**MUNICIPAL SERVICES CENTER, COUNCIL CHAMBER
3600 TREMONT ROAD**

BZAP Meeting Date: September 6, 2023

Subject: 2096 Jervis Road (VAR-40-23) - To allow the construction of a second-story addition atop the existing footprint (with a slight expansion) that encroaches 1.7 feet (west) and 1.1 feet (east) into the eight-foot minimum side yard setbacks, resulting in a side yard sum setback of 13.2 feet, in lieu of the 16-foot minimum. The height of the house also exceeds the neighborhood compatibility standards by eight inches.

Subject: 3230 Northwest Boulevard (DEV-03-23) - Review of a Major Site Plan application to allow for the demolition of a vacant two-story office building and the construction of a two-story child day care center for The Barrington School of Kingsdale.

PROPOSED SITE PLAN

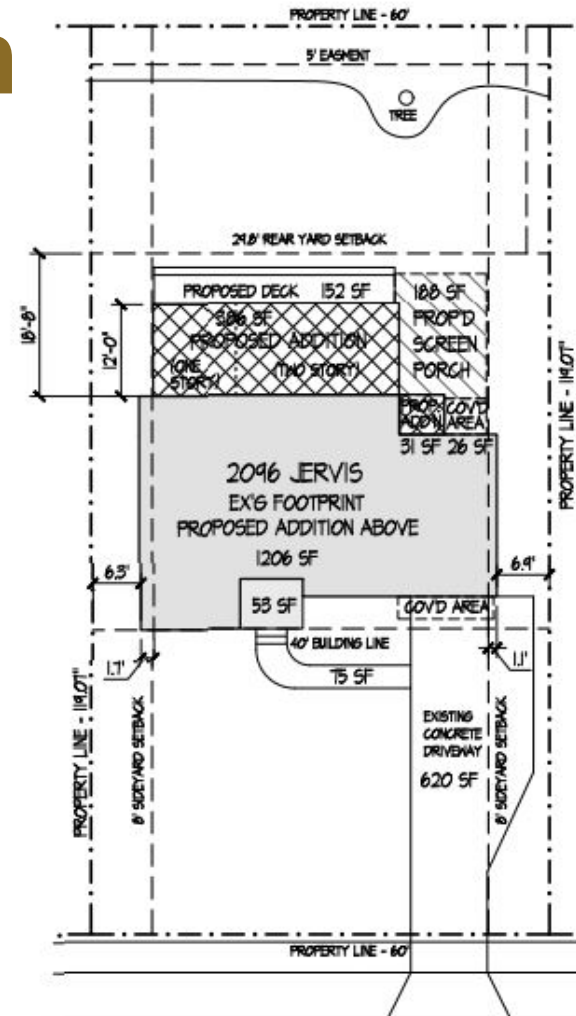
- To allow the construction of a second-story addition atop the existing footprint (with a slight expansion) that encroaches 1.7 feet (west) and 1.1 feet (east) into the eight-foot minimum side yard setbacks, resulting in a side yard sum setback of 13.2 feet, in lieu of the 16-foot minimum (Article 5.02); and

Requesting sideyard variances to replace a "half" second story with a full second story on top of an existing first floor footprint . The existing conditions are non-compliant as the house projects into the 8' sideyard setbacks (1.7' on the west side and 1.1' on the east side).

PROPOSED SOUTH ELEVATION (FRONT)

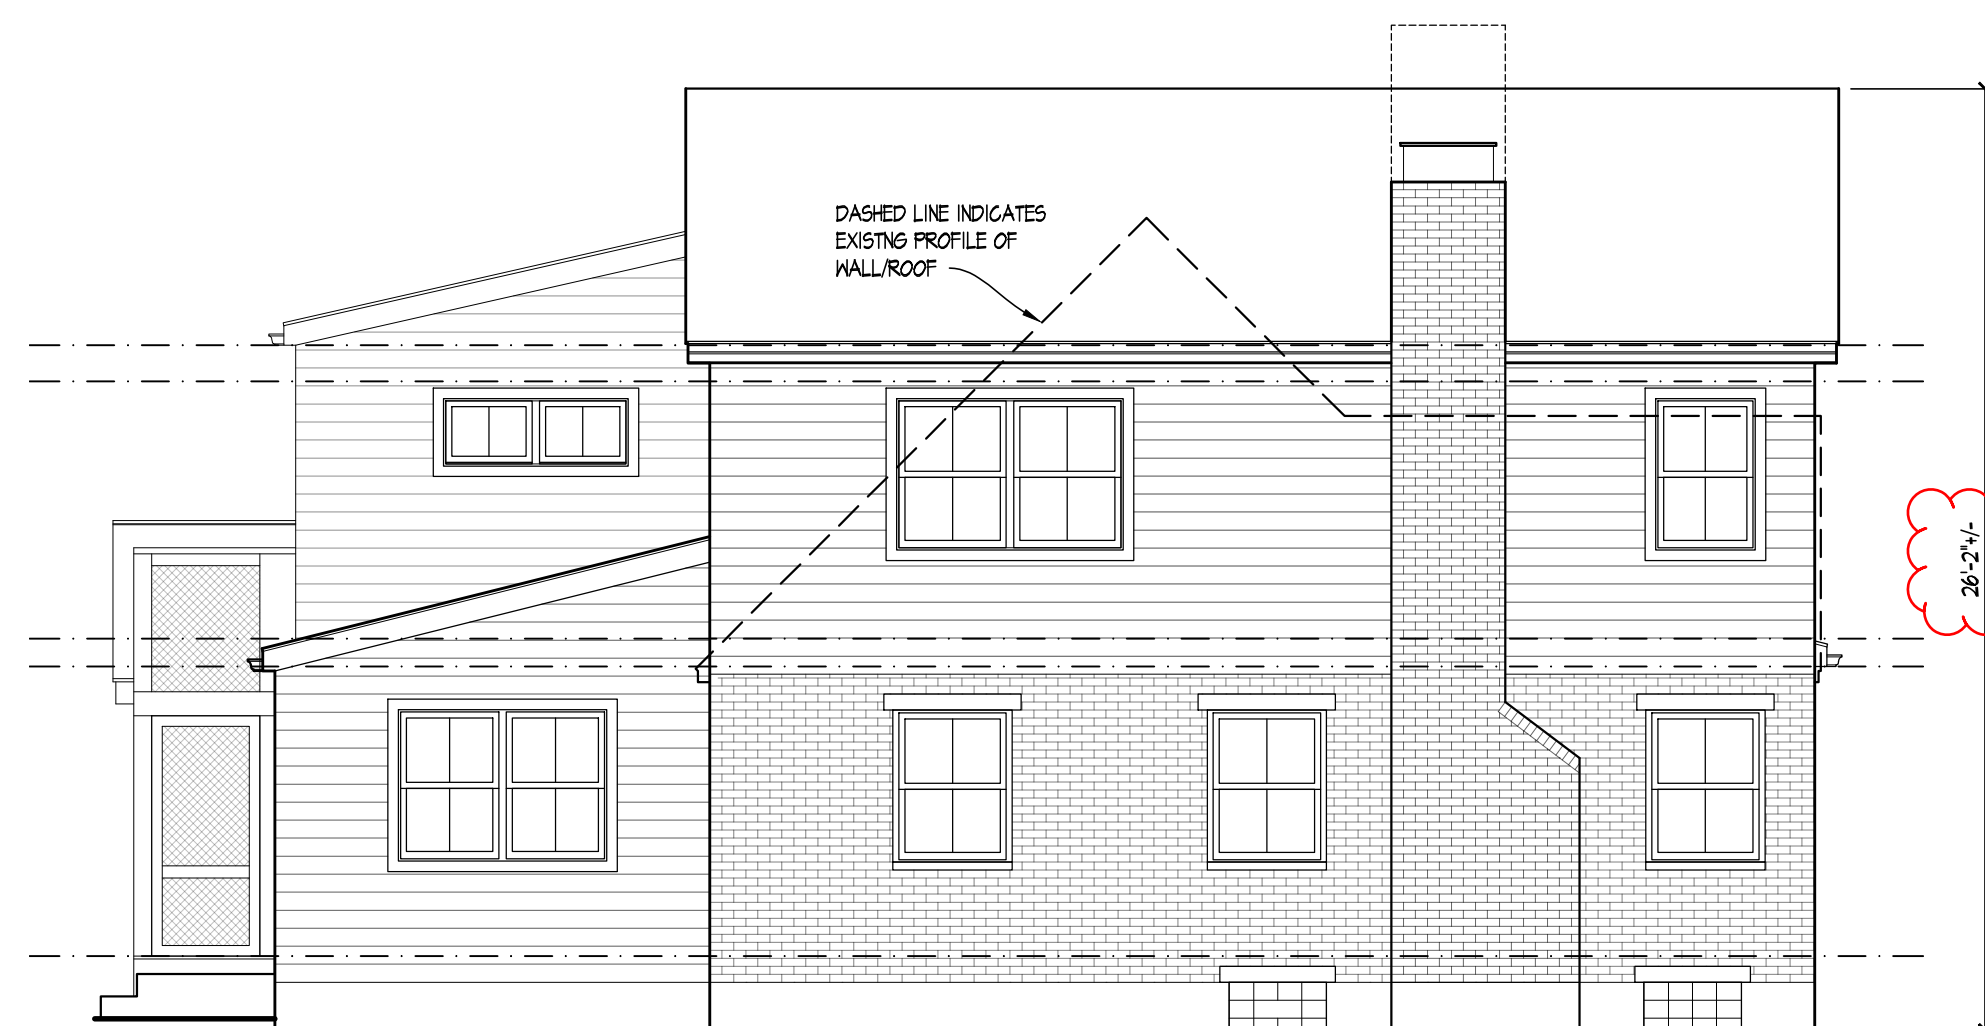
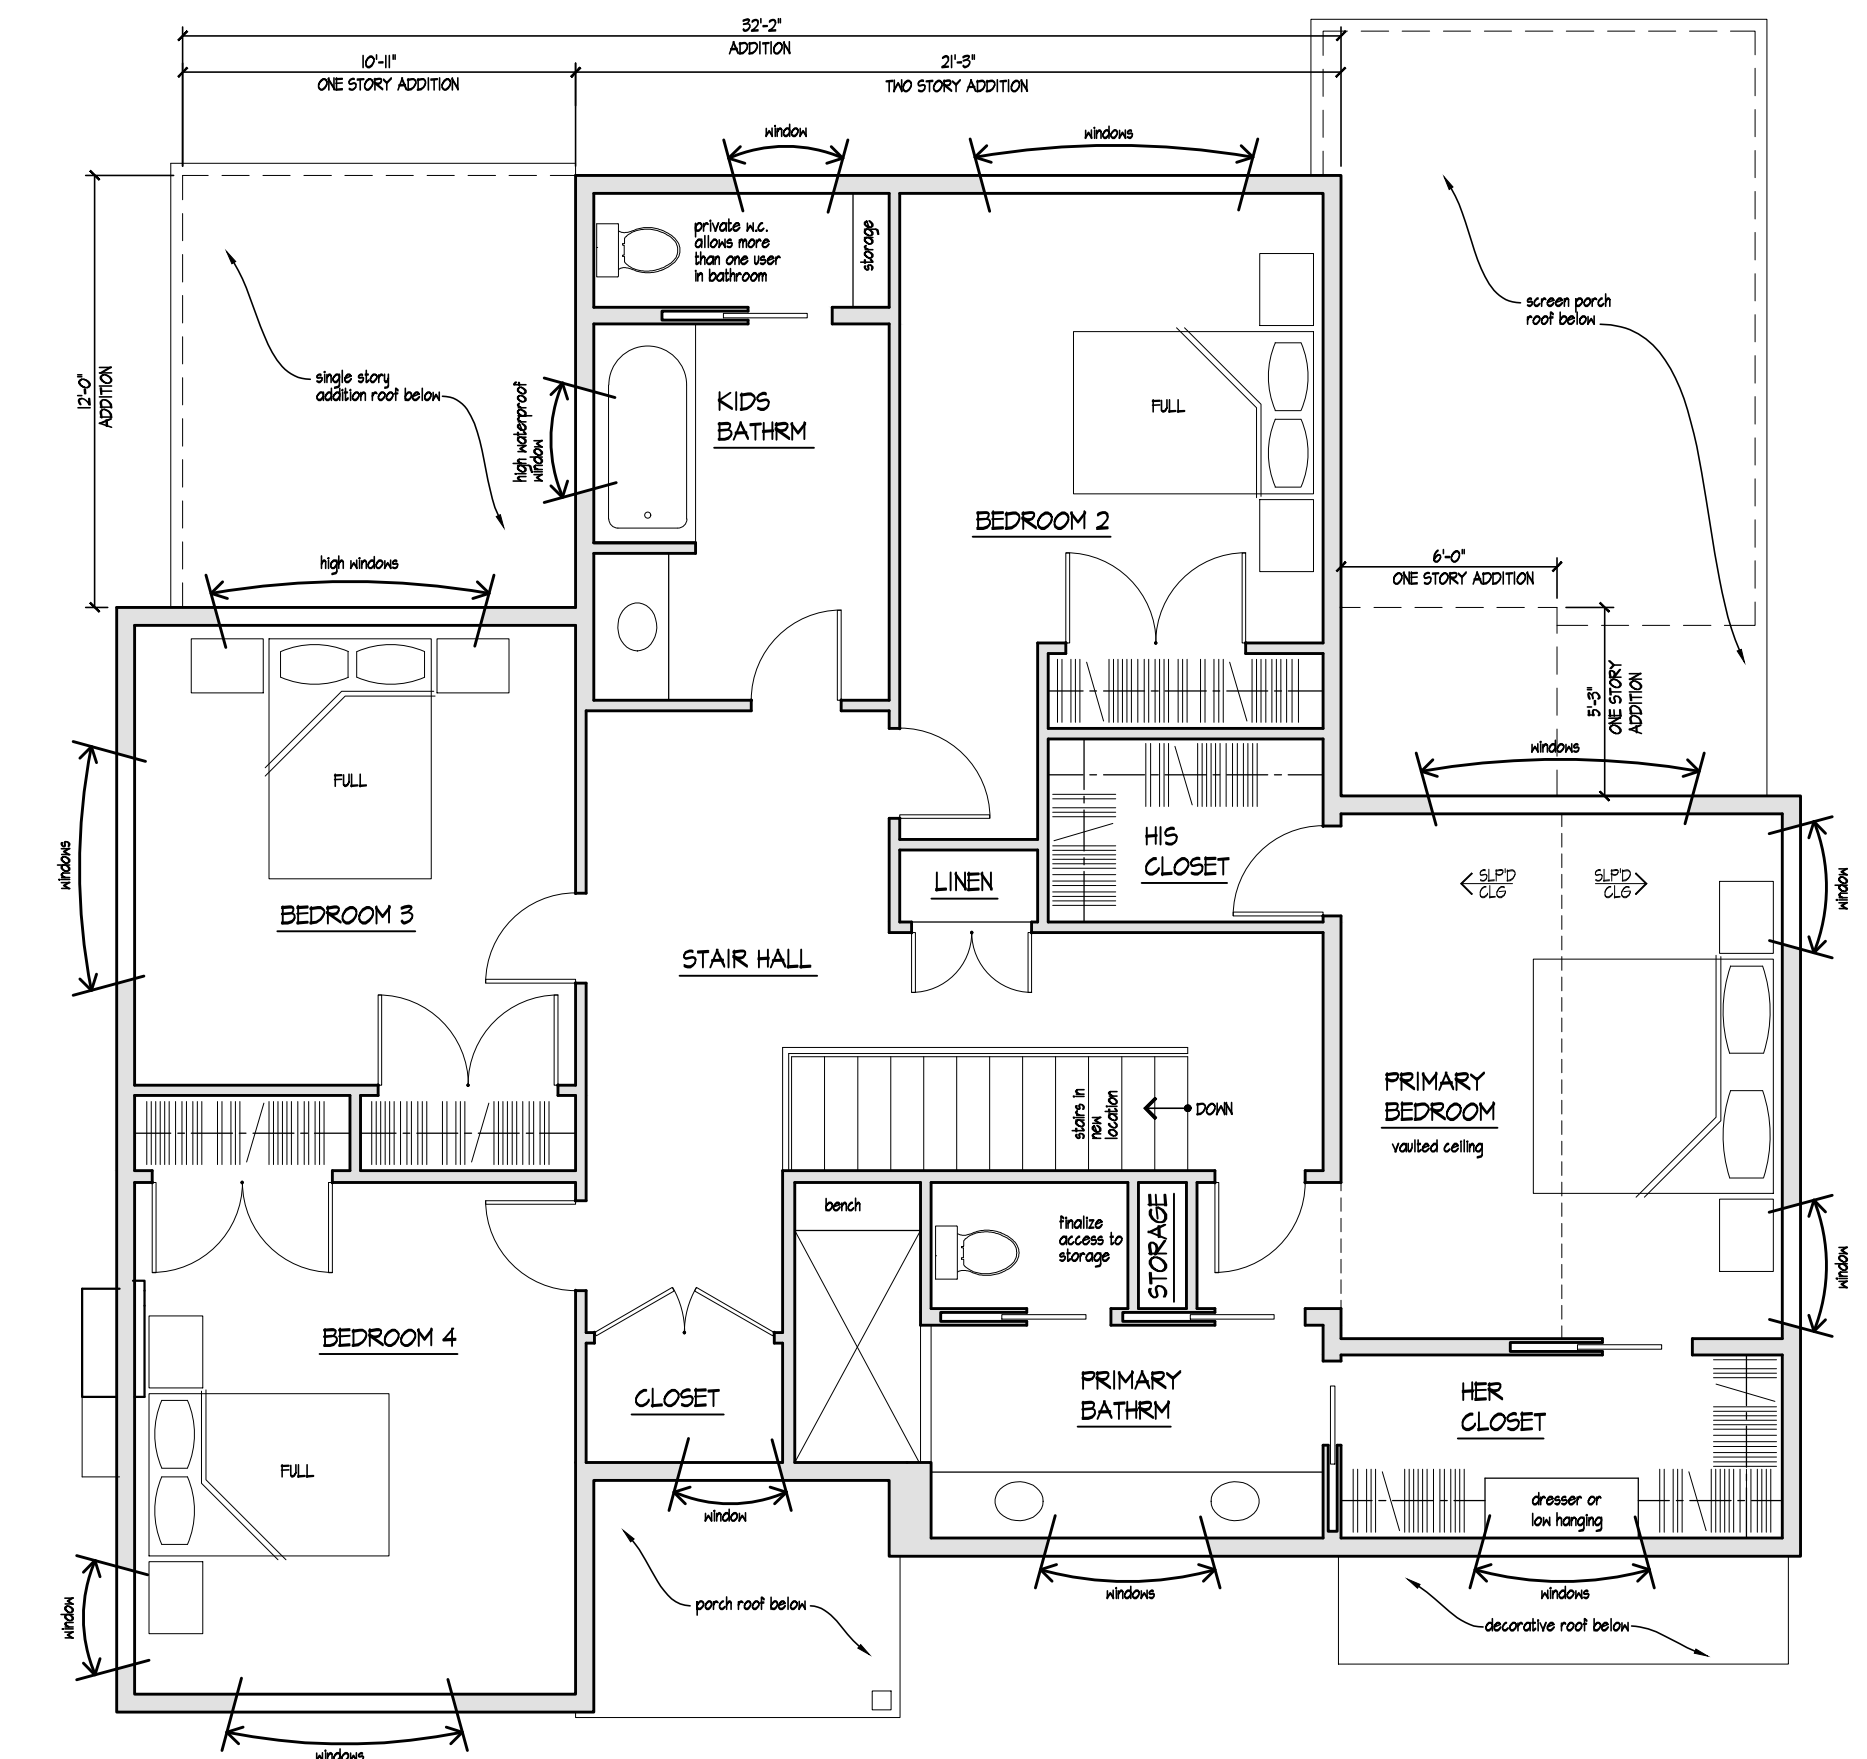
- The height of the house exceeds the neighborhood compatibility standards by eight inches (Article 7.17).

SP1.1

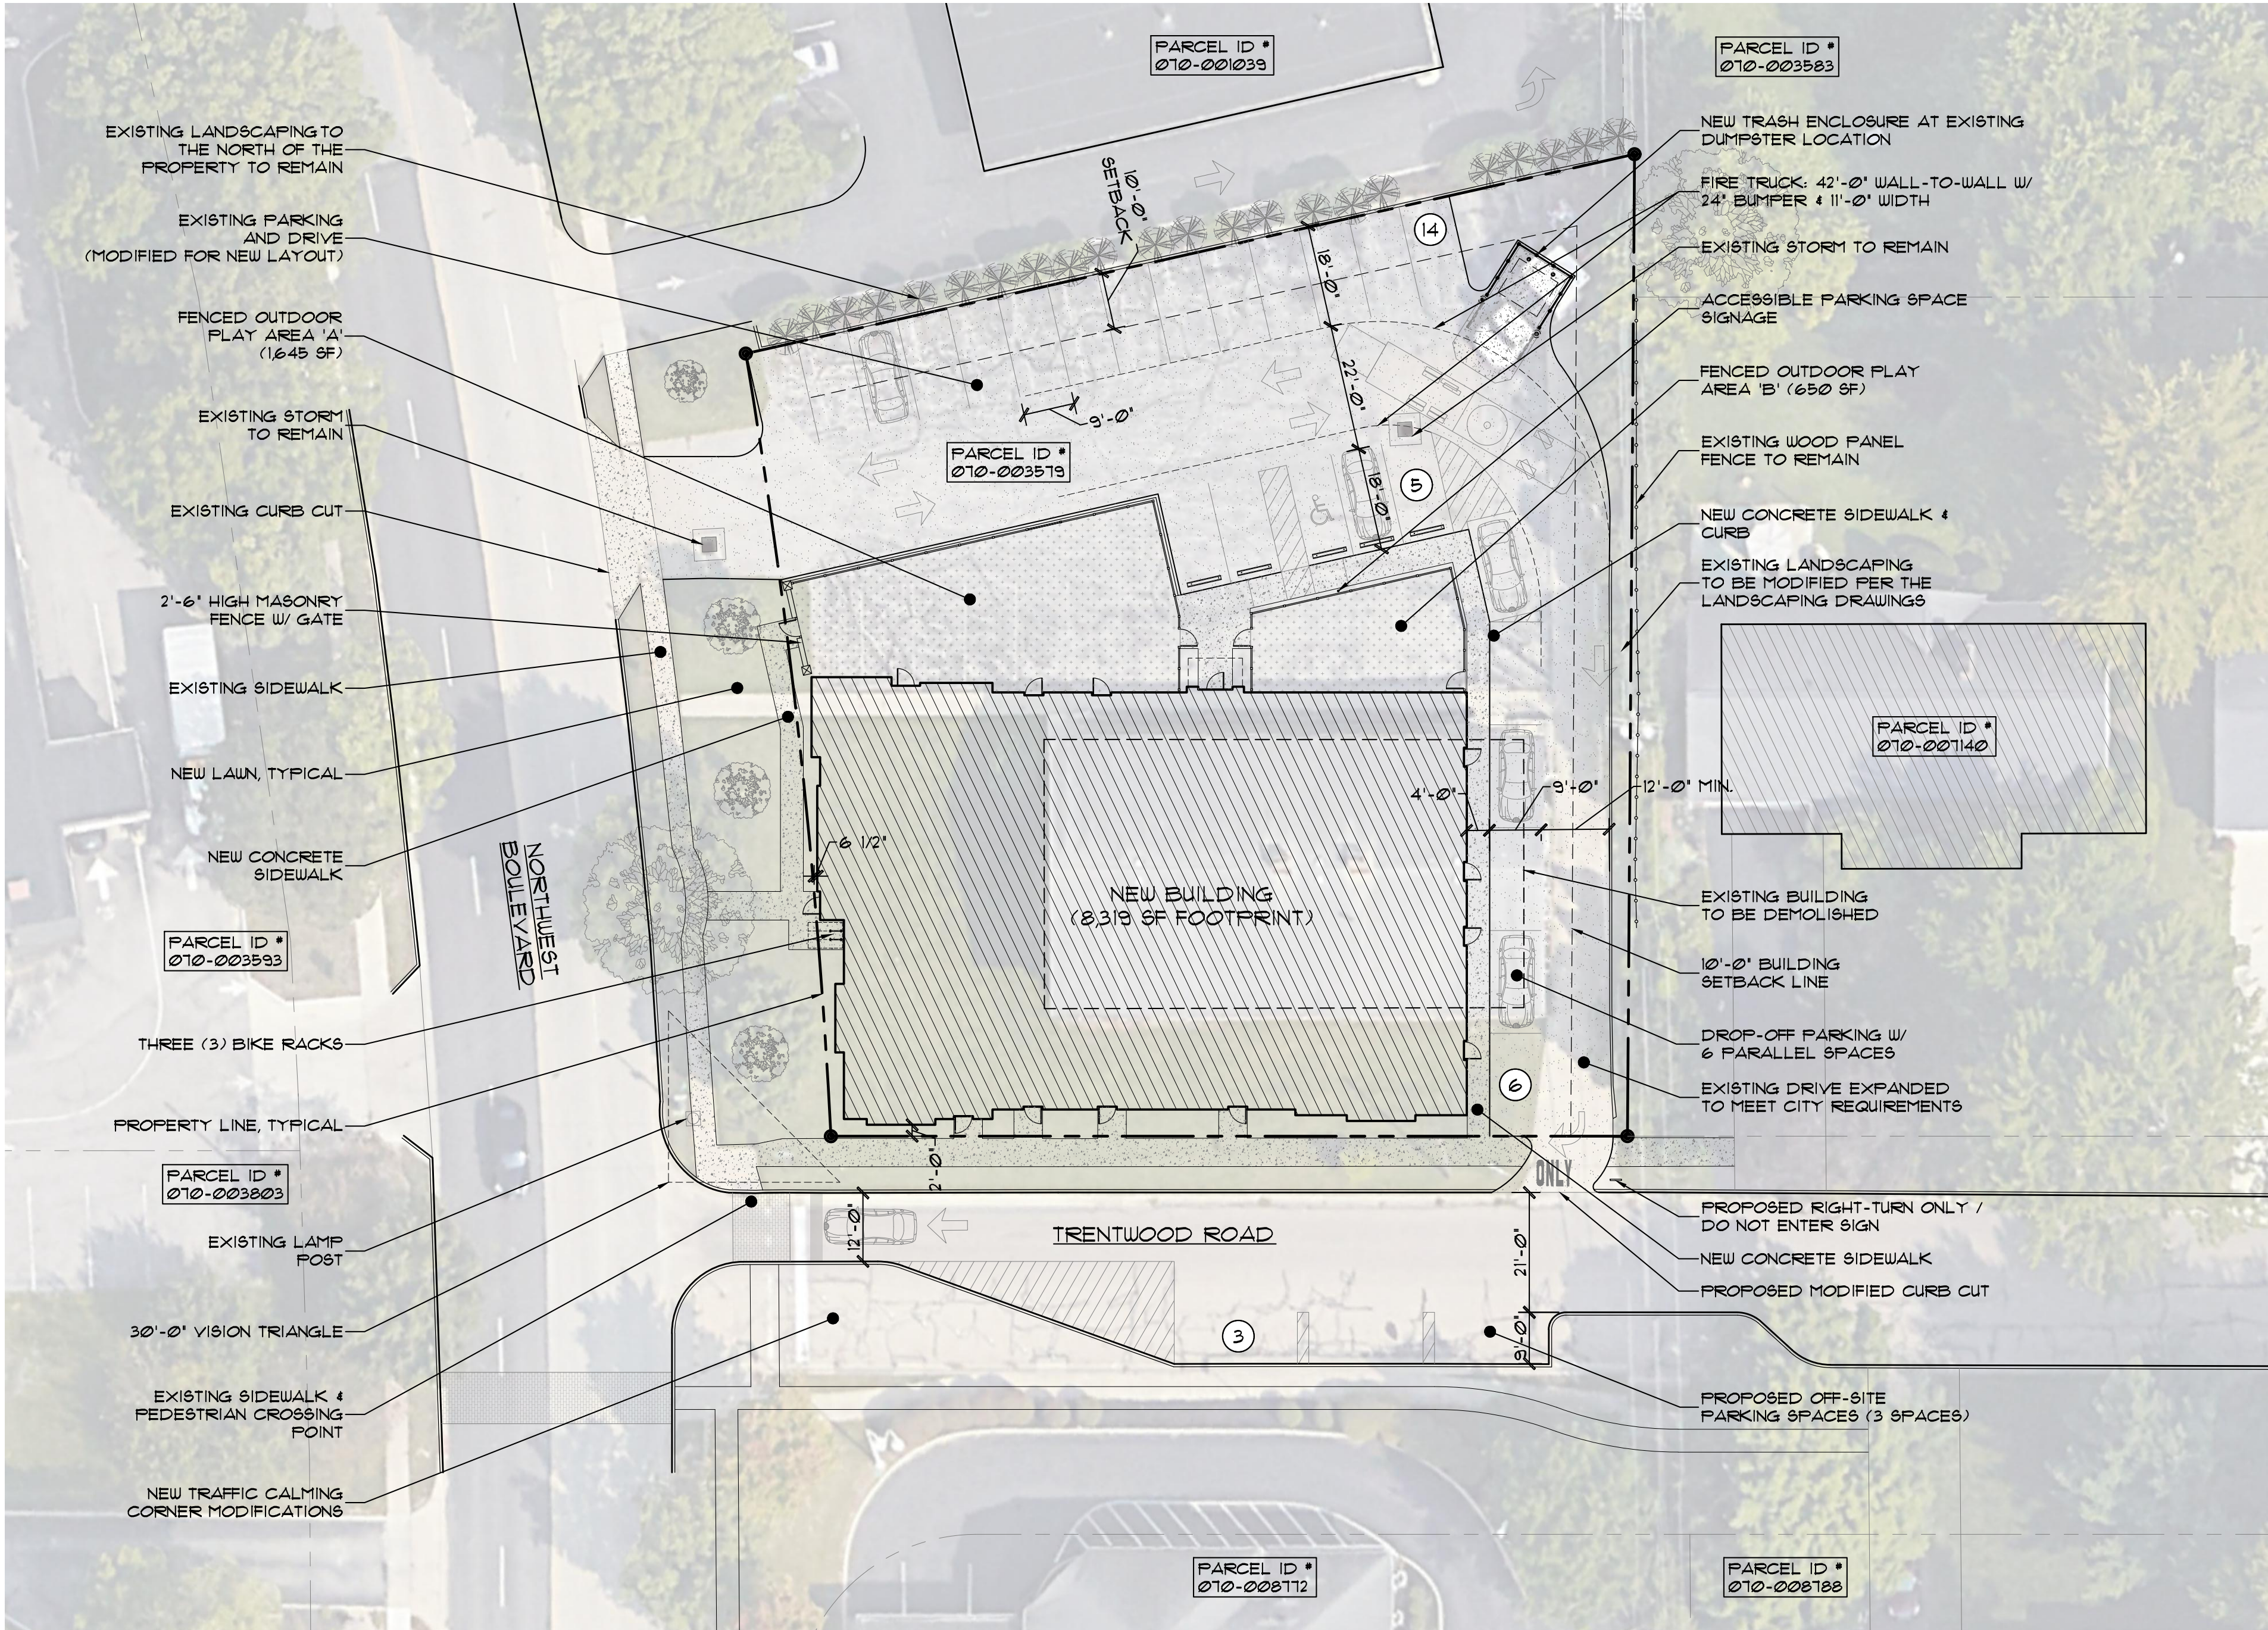
- 6) **Traffic Management** – The City Engineer has approved the proposed site access and circulation pattern, and is also supportive of the three off-site parking spaces provided on the south side of Trentwood Road. Please continue to coordinate this potential improvement with the City's public works project and our plans. Please also investigate for any potential site visibility triangle obstructions.

- 7) **Parking** – Thank you for supplying additional information on the center's parking needs utilizing comparable examples. While a variance is needed, the information supplied appears to be sufficient. Should a parking problem arise, an off-site parking arrangement will be needed. Please note on the site plan where any shuttle buses/vans will be parked. Also, thank you for offering to allow after-hours parking for the City's future community center across the street at Kingsdale.
